Access Compliance Report

Public Rights-of-Way

(Curb Ramps)

Intersection ID: 7728	Main Street: COUNTRYSIDE_DR	Cross Street: W_ARROWHEAD_DR	Location: SE
ADA ID: 94D8CC37E673	Ramp Type: BlendTrans1	Initial Pass/Fail: Fail	Overall Compliance: No
Severity Score: 10			
Codes/Mitigation Info/Possible Solution		Field Measurements/Component Compliance

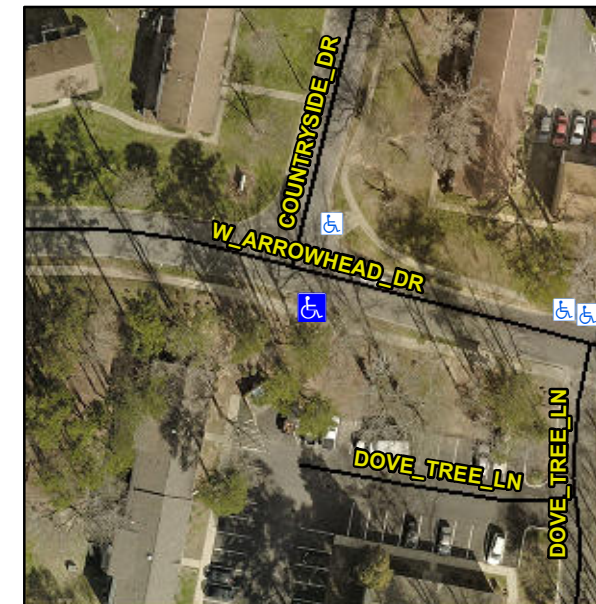
Not Found, R304.5.1, R304.5.3

Compliance	Description	Data	Compliance	Description	Data
N/A	Ramp Length (in)	47.0	Yes	BlendTrans Slope (%)	3.4
No	Ramp Width (in)	47.5	No	BlendTrans XSlope (%)	2.4
N/A	Flare Type LT	N/A	N/A	Flare Type RT	N/A
N/A	Flare Slope LT (%)	N/A	N/A	Flare Slope RT (%)	N/A
N/A	Flare Traversable LT?	N/A	N/A	Flare Traversable RT?	N/A
N/A	Landing Length (in)	N/A	N/A	DWS Provided?	N/A
N/A	Landing Width (in)	N/A	N/A	DWS Contrast?	N/A
N/A	Landing Slope (%)	N/A	N/A	DWS Length (in)	N/A
N/A	Landing X Slope (%)	N/A	N/A	DWS Full Width?	N/A
N/A	Landing Curb? (Y/N)	N/A	N/A	DWS Offset (in)	N/A
N/A	Shared Landing?	N/A			
N/A	Gutter Ponding?	N/A	N/A	Gutter Slope (%)	N/A
N/A	Gutter Lip Ht (in)	0.5	N/A	Gutter X Slope (%)	N/A
N/A	Painted X Walk1?	No	N/A	Painted X Walk2?	N/A
	X Walk 1 Direction	To NE		X Walk 2 Direction	N/A
	X Walk 1 Width (in)	N/A		X Walk 2 Width (in)	N/A
	X Walk 1 Slope (%)	5.2		X Walk 2 Slope (%)	N/A
	X Walk 1 X Slope (%)	1.3		X Walk 2 X Slope (%)	N/A

N/A	Ramp inside XWalk1?	N/A	N/A	Ramp inside XWalk2?	N/A
	Road Slope (%)	1.3		Clear Space?	N/A
	Road X Slope (%)	5.2	N/A	Clear Space to XWalk (in)	N/A
N/A	Any Obstructions?	N/A	N/A	Storm Grate/Utility Hazard?	N/A
	Obstruction Type			Storm Grate/Utility Type	
		N/A			N/A
			Yes	Surface Condition? (G/P)	Good
			No	Curb Slope (%)	24.4

Remove & Replace Curb Ramp With Two New Directional Ramps or Equivalent.
